APPLICATION RESPONSE

Comments following submission of planning application HGY/2023/1208 to upgrade of a current make shift BMX trail into permanent trail for children of all ages:

The land adjacent to 1 Shepherds Hill, London, N6 5QJ

Shepherds Hill BMX Trail - Application Comments

7.1 Google Streetview showing the site between Nov 2009 and Mar 2023:

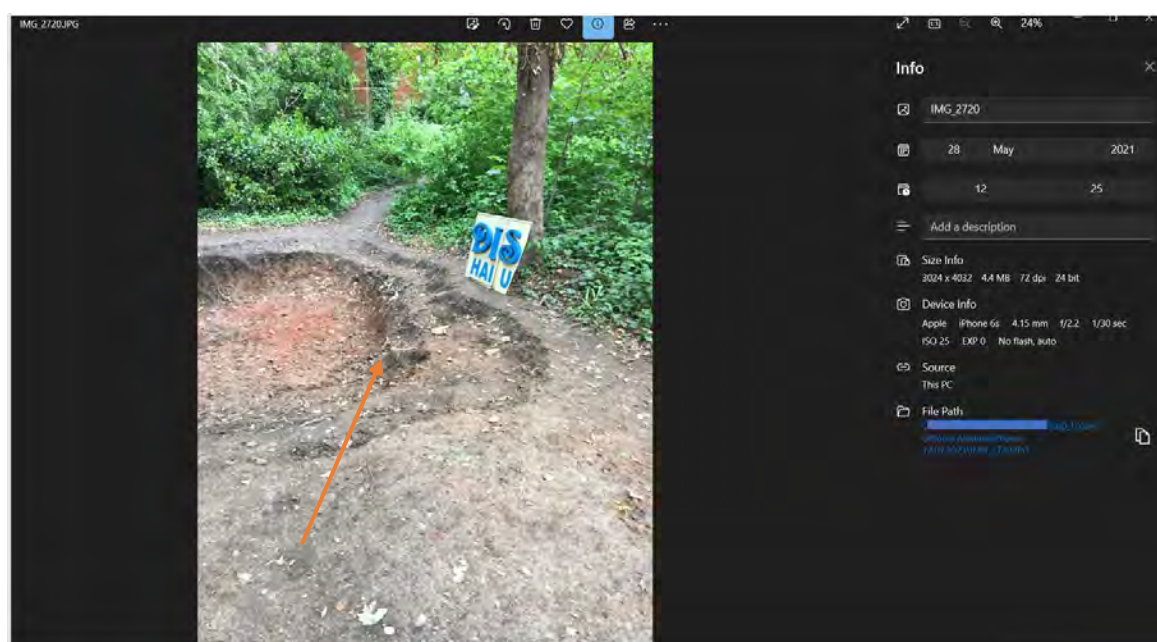
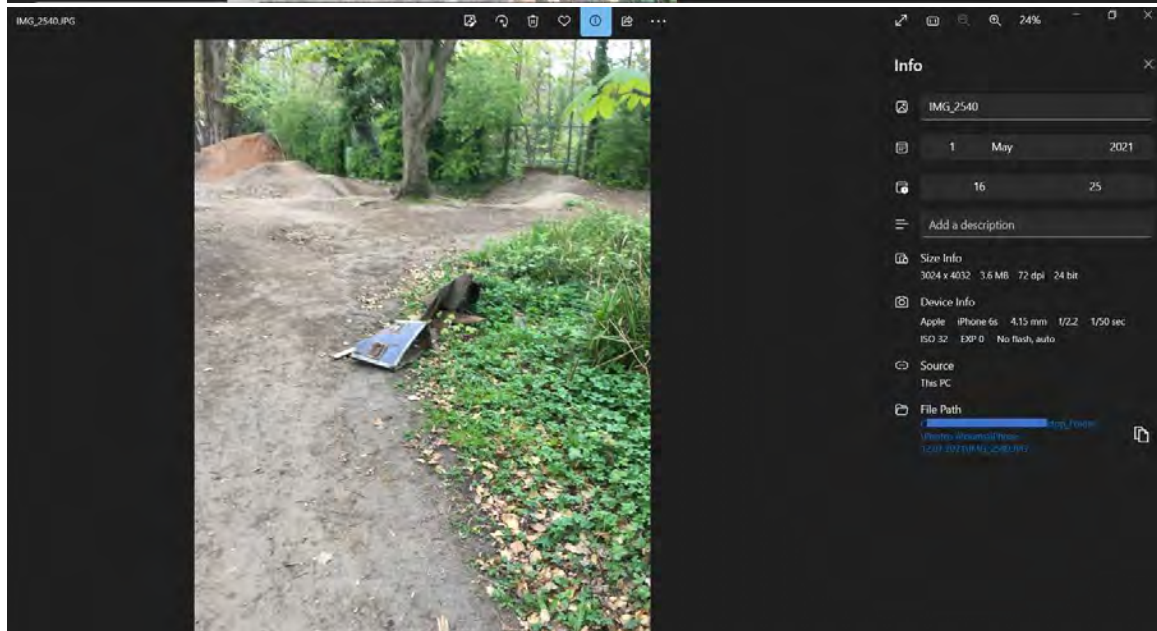
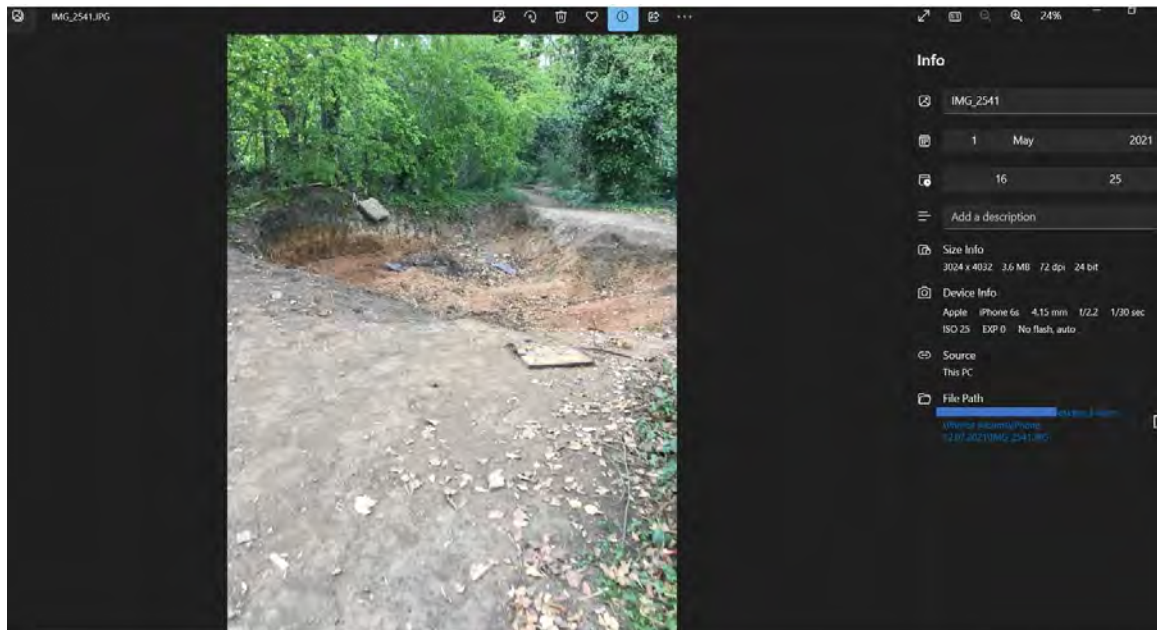
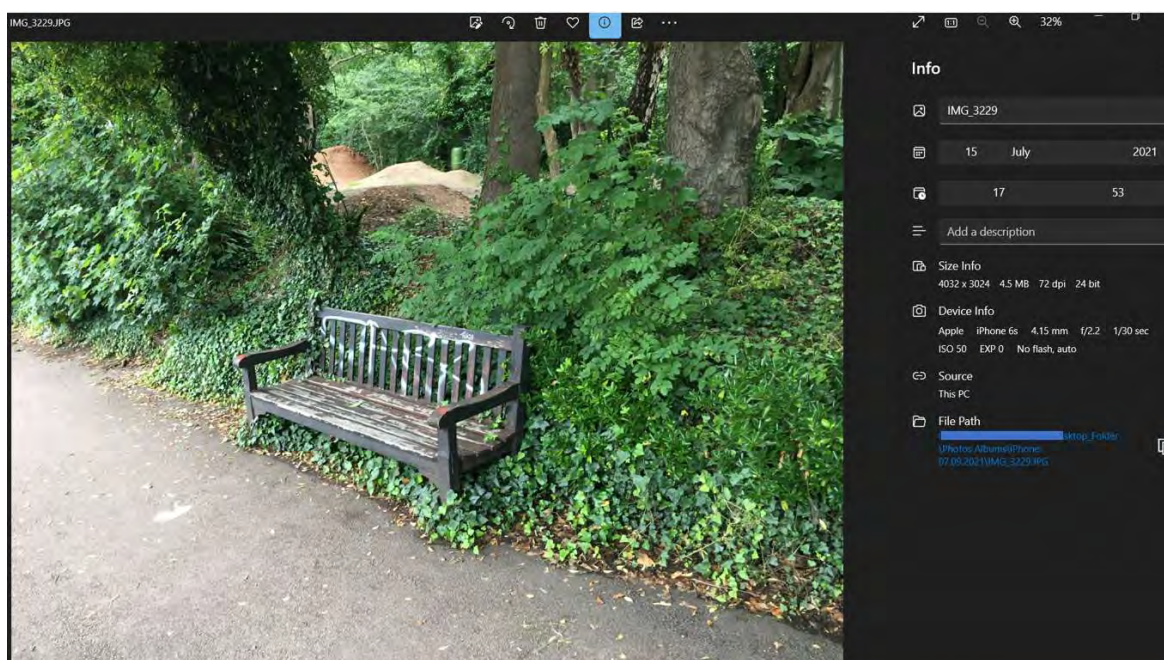
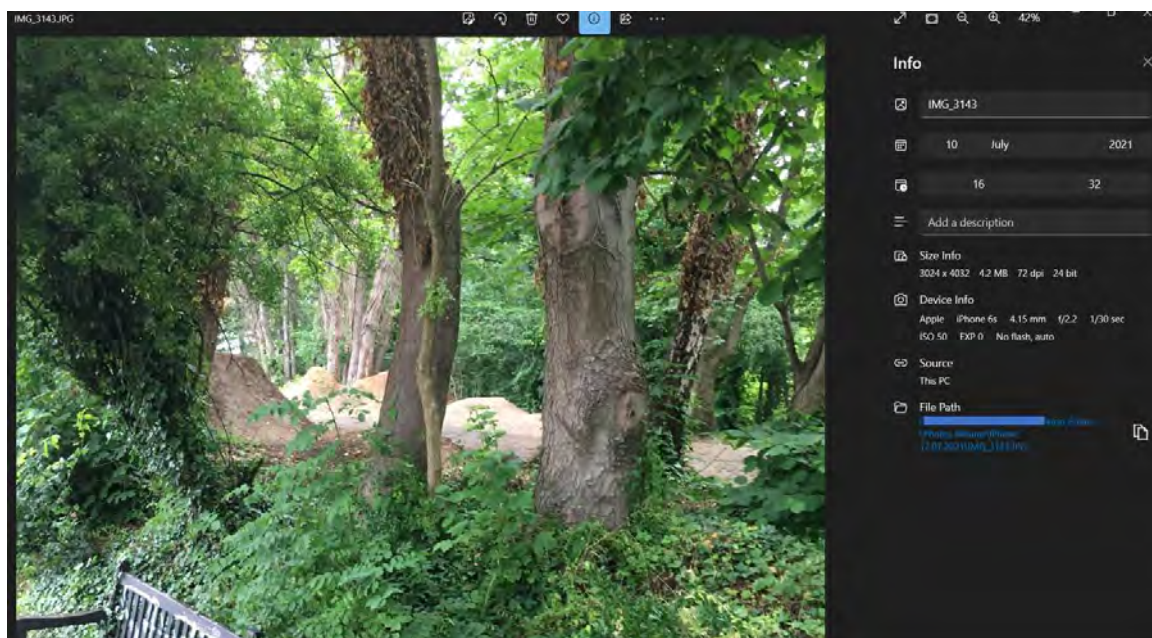
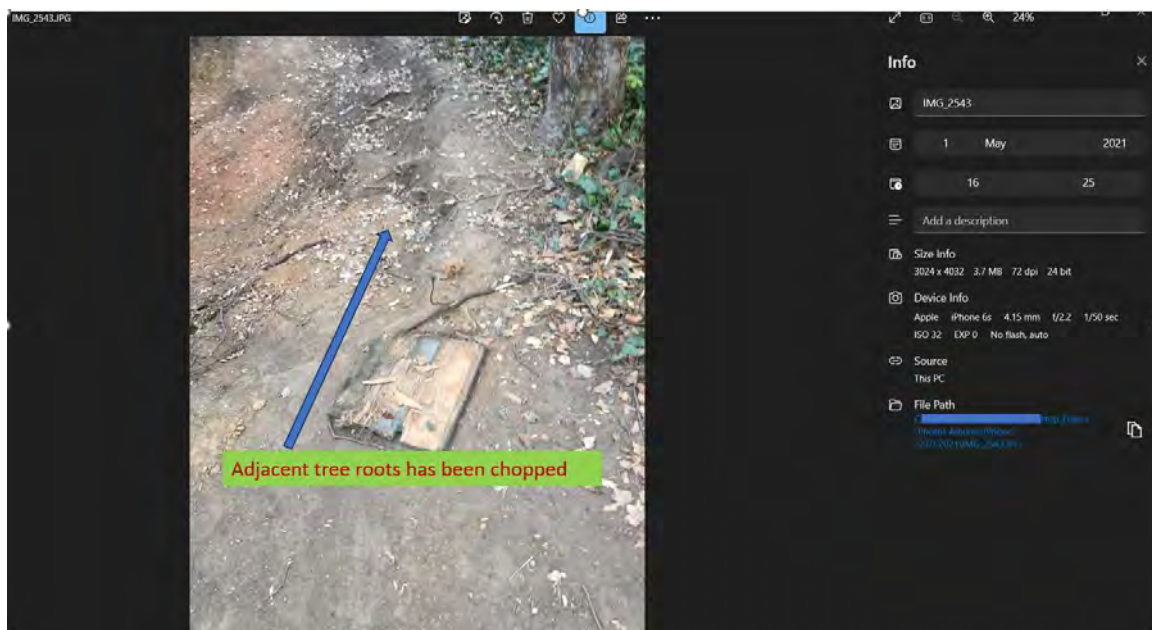
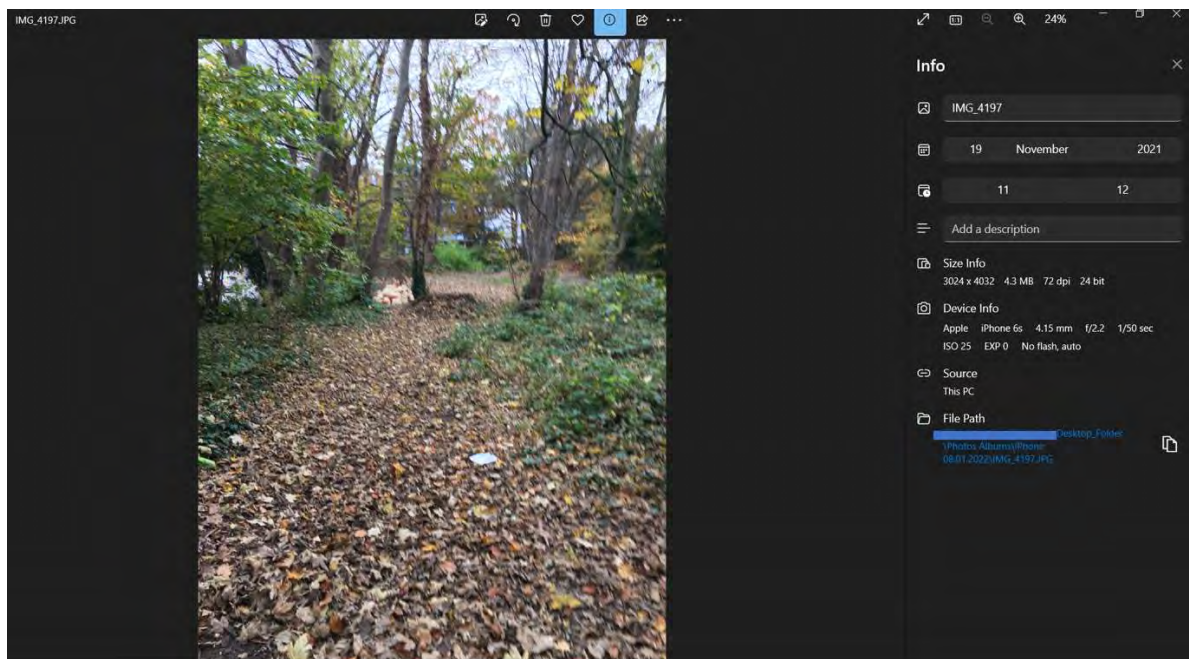
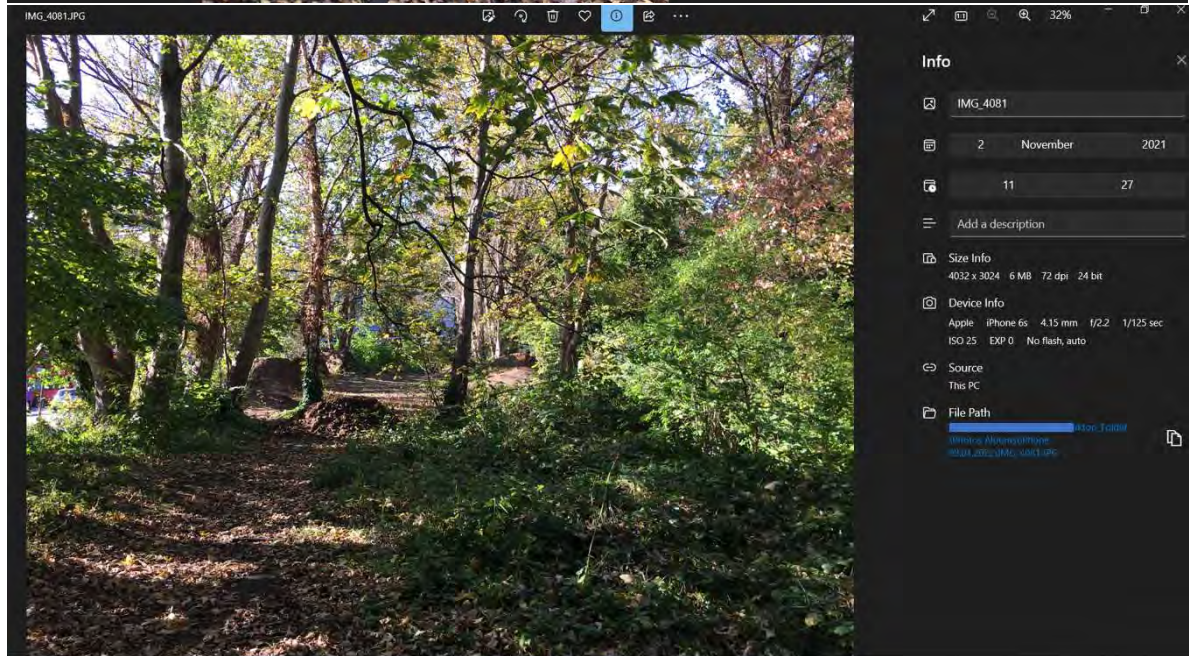
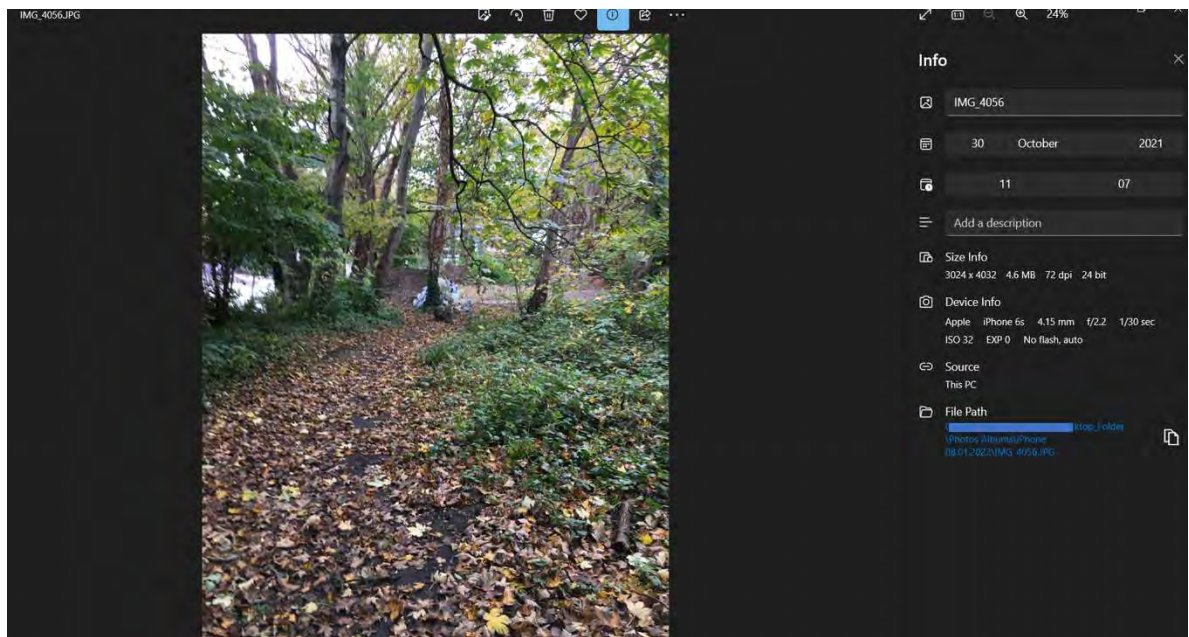
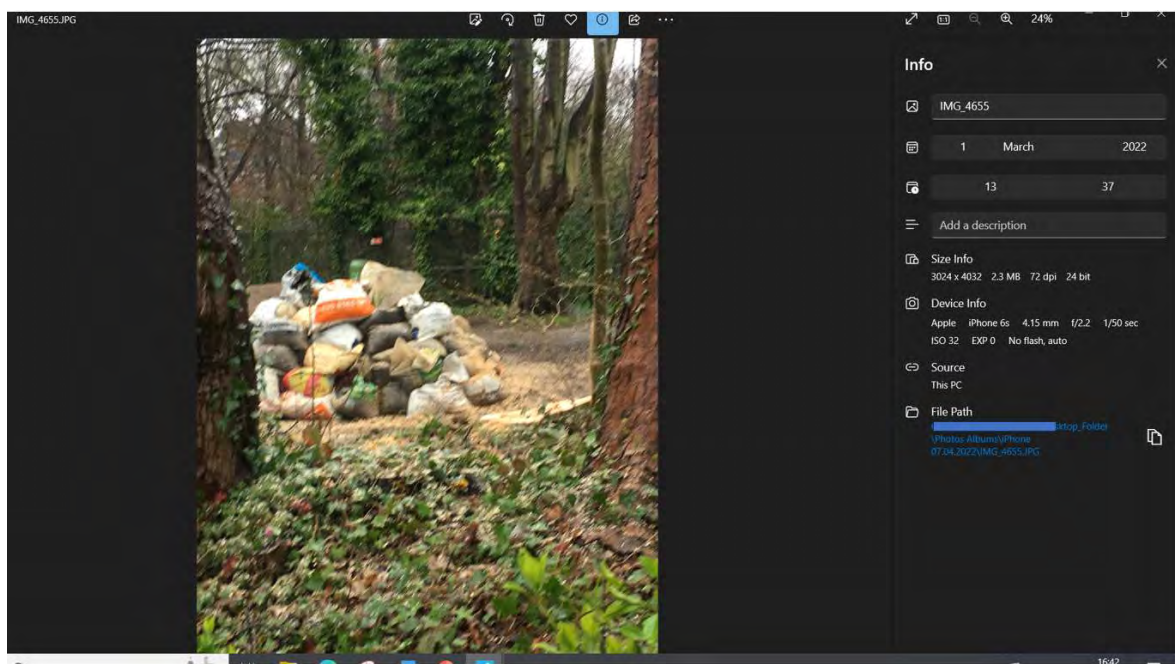
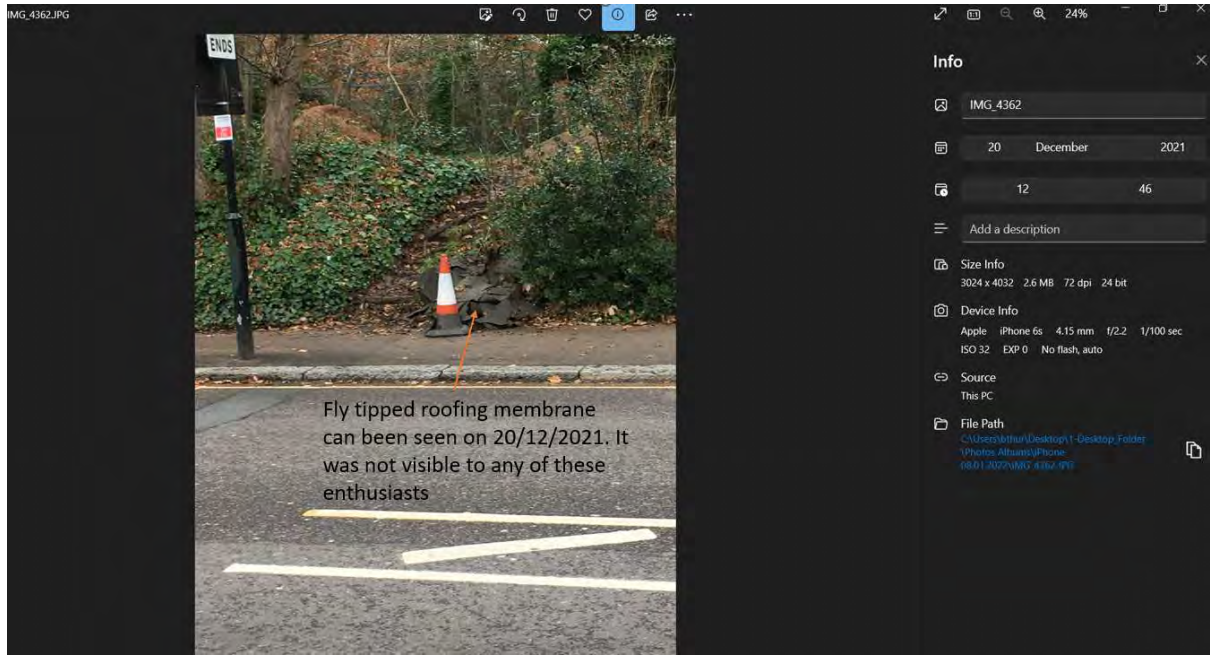
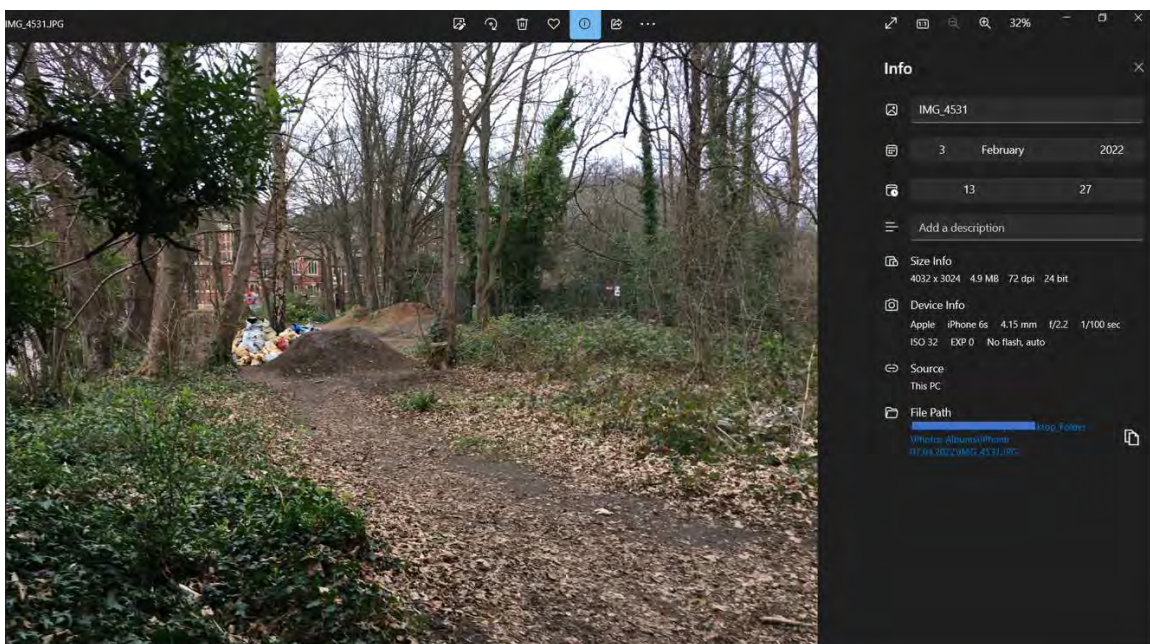
The application states that there has been a 'makeshift' BMX track on the site for a number of years. This statement is very misleading as there has never been a BMX 'track' on the site other than a few built up mounds closer to metal fence that separates the London Underground in 2012 following the Summer Olympics that year. Apart from felling of eight diseased trees by Haringey in Feb 2022, the site has been illegally cleared over the last three years without due regards to neighbouring properties.

This can be verified on Google Streetview. Attached photos taken over recent years show that this site has never been used as an informal bike park. A few mounds of mud would not constitute as an informal bike park. The random Google Streetview scene from 2009 to 2023 shows no such activities. *(Please refer to photos in Section 7.1)*
